DEVELOPMENT APPLICATION ASSESSMENT REPORT

Application Number:	DA2025/0555
----------------------------	-------------

Responsible Officer:	Dean Pattalis
Land to be developed (Address):	Lot 7 DP 244645, 14 Warekila Road BEACON HILL NSW 2100
Proposed Development:	Alterations and additions to a dwelling house
Zoning:	Warringah LEP2011 - Land zoned R2 Low Density Residential
Development Permissible:	Yes
Existing Use Rights:	No
Consent Authority:	Northern Beaches Council
Land and Environment Court Action:	No
Applicant:	JJ Drafting Australia Pty Ltd

Figure 1: Site Plan with excavated sub-floor area shown hatched

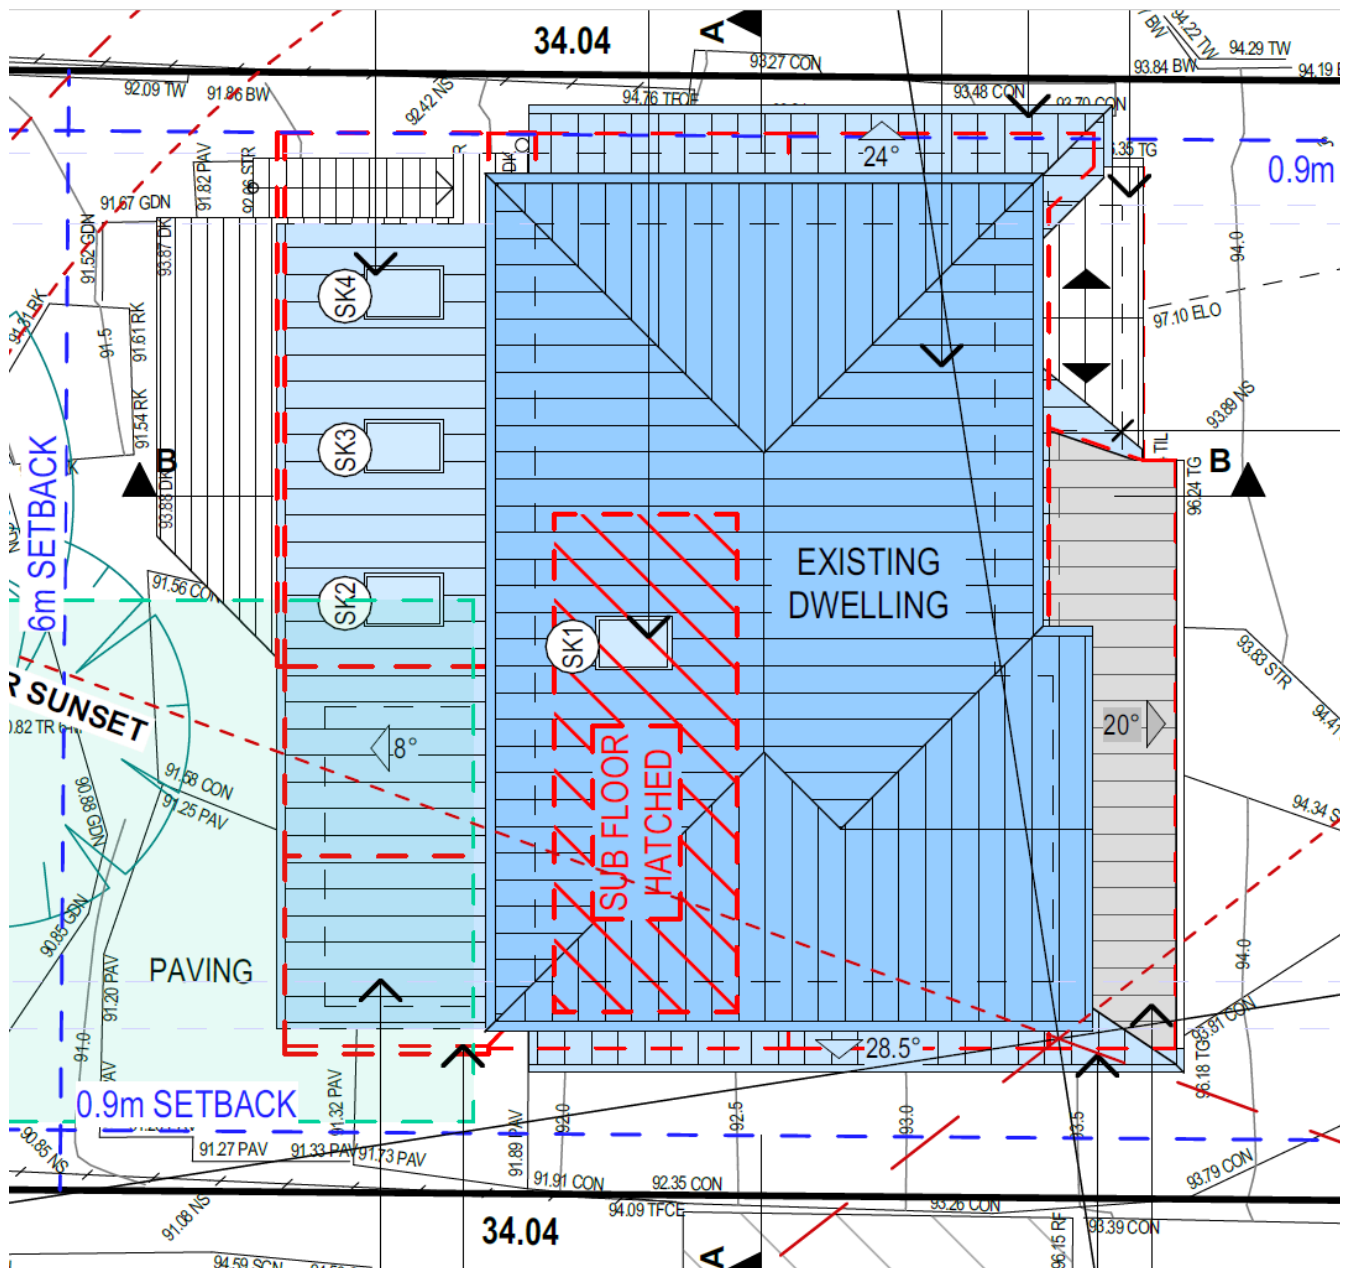
The proposed numerical non-compliance is the result of the FFL of the existing excavated lower ground floor which currently sits below the natural ground level of the site. The proposal is numerically compliant above the natural extrapolated ground level.

The assessment concurs with the applicant's justification as represented by Figures 1 and 2 above. The proposal results in numerical compliance above the natural extrapolated ground level and therefore achieves consistency with the desired future character of the locality and streetscape. The proposal is also numerically compliant with all built form controls of WDCP 2011, with the exception of a minor protrusion outside the building envelope at the rear corner of the side elevations. The proposal is wholly numerically compliant when viewed from the streetscape.

Figure 3: Northern envelope non-compliance

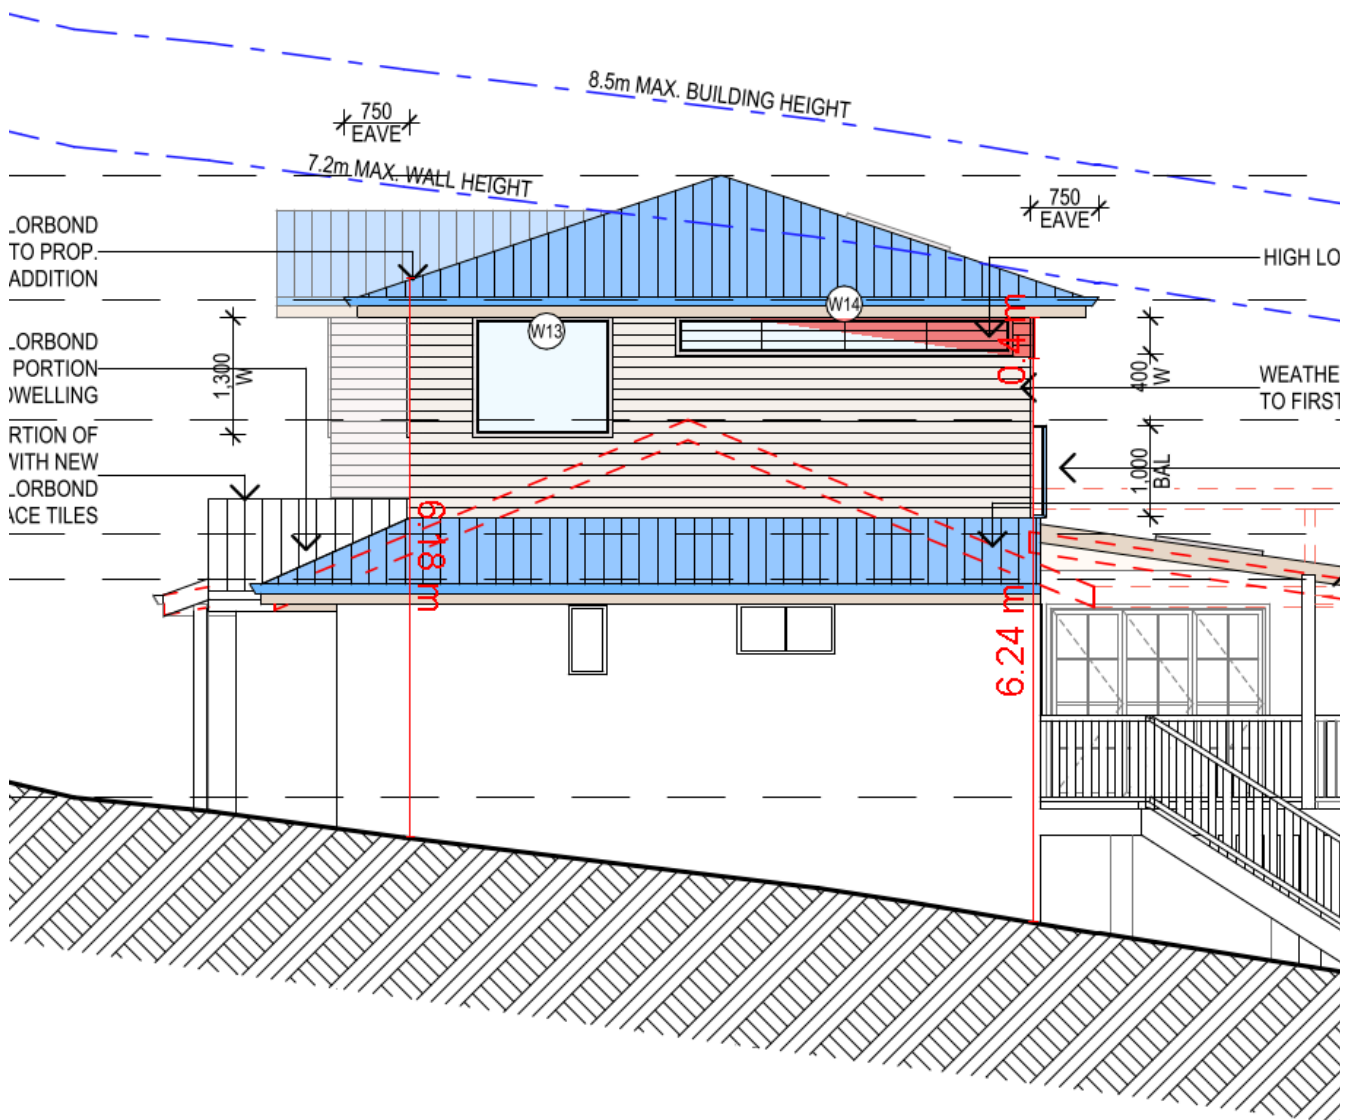
The proposed first floor encroaches the building envelope by a maximum of 0.4m on the northern side elevation and 0.2m on the southern side elevation.

The proposed variation is considered minor as it is noted the extent of non-compliance is located at the far rear corner of the side elevation, with the front portion presenting to the streetscape being wholly compliant.
